Stormwater Management Plan

67-69 Shore Street East, Cleveland

Project Number: 23191
Document Number: 23191-RPT-CV-0001
Revision: B

1.1 RFI Response

Figure 5-4: DRAINS Results (10% AEP)

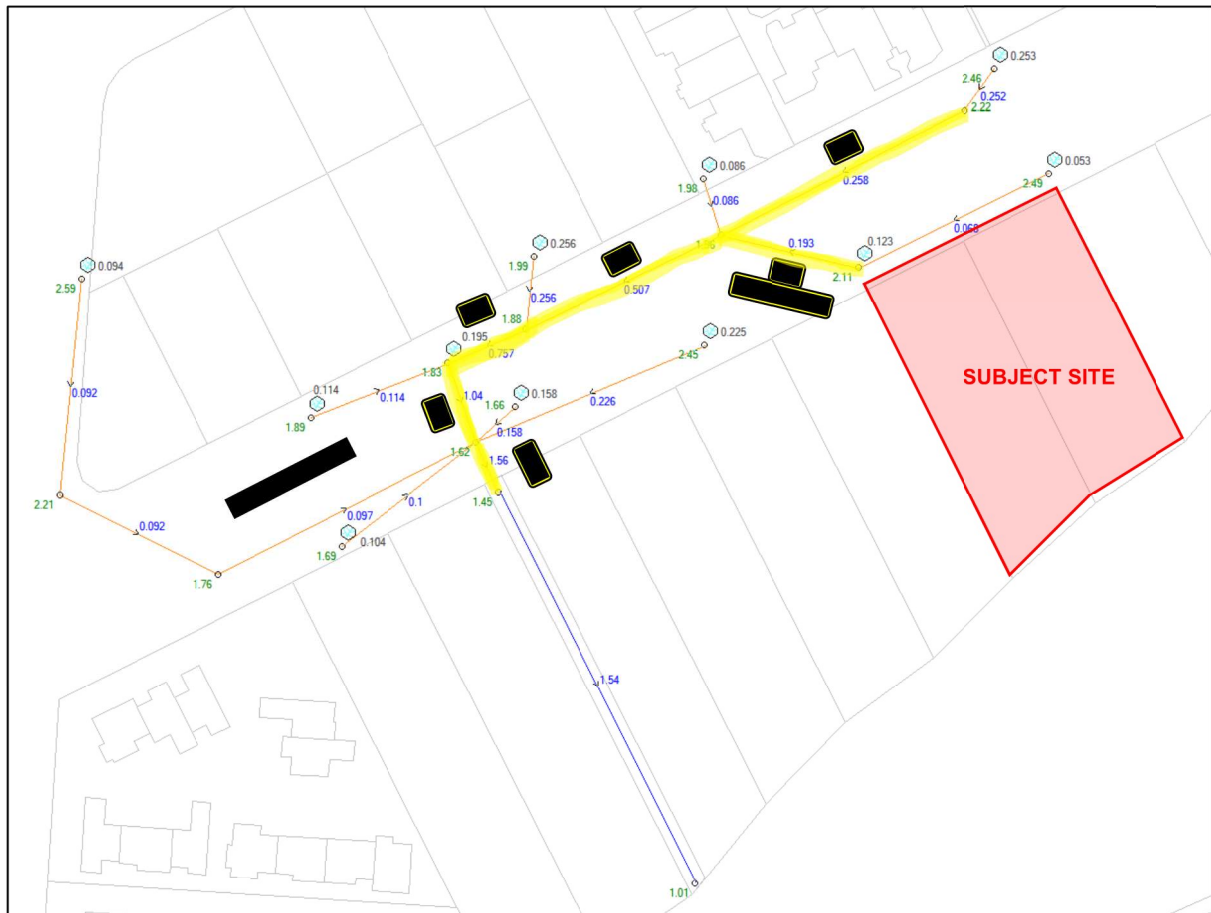
| RFI Item | Response |
|--|---|
| 5b: A 1% AEP flow from the site will be connected to the existing 525mm diameter pipe located in the verge on the northern side of Shore St East. A network analysis with the assumptions made in Section 5.3.1 of the stormwater management plan revealed that the existing stormwater infrastructure along Shore St East has adequate capacity to convey the flow from the fully developed catchment during storm events up to and including the 1% AEP, with a very slight surcharge likely at some upstream drainage structures which would result in road flow depths of less than 300mm. Demonstrate the following: <ul style="list-style-type: none"> Whether blockage factors of the pits are considered for the proposed 1%AEP internal flow (2100 climate change scenario). Please provide a plan showing the extent of the flood hazard extent in the road likely to be resulted due to the proposed stormwater connection/diversion. Clearly identify the size of the new pipe from the site on to the existing on the road 525mm diameter pipe. | <p>No blockage factors have been considered, as the pits on site are located in an undercover carpark which will be limited to capturing drips from cars or windblown rain from the entrance. There is limited opportunity for blockages of the pits and the volume of runoff captured is negligible.</p> <p>The large majority of runoff from site is captured by gutters located above the treeline and conveyed via downpipes and the underground stormwater networks which does not require blockage factors. See section 5.3.1 for further details.</p> <p>As discussed with the assessing engineer, there is a reduction in surface runoff contributing to the roadway of Shore Street East under developed conditions due to the large majority of the site runoff being conveyed directly to the existing stormwater network via new pipes.</p> <p>The surface runoff contributing to the roadway is limited to the driveway only and does not warrant a dedicated flood hazard extent plan, as there will not be any increase in the flood hazard resulting from surface flows from the proposed development. See section 5.3.6 for further details.</p> |

| RFI Item | Response |
|---|--|
| | <p>The proposed stormwater pipe joining the proposed development to the existing 525mm diameter pipe on the north side of Shore St East will be a 450mm diameter RCP and has been clearly labelled in Figure 5-4. It is noted that the final sizing of the pipe network will be subject to a detailed design assessment.</p> |
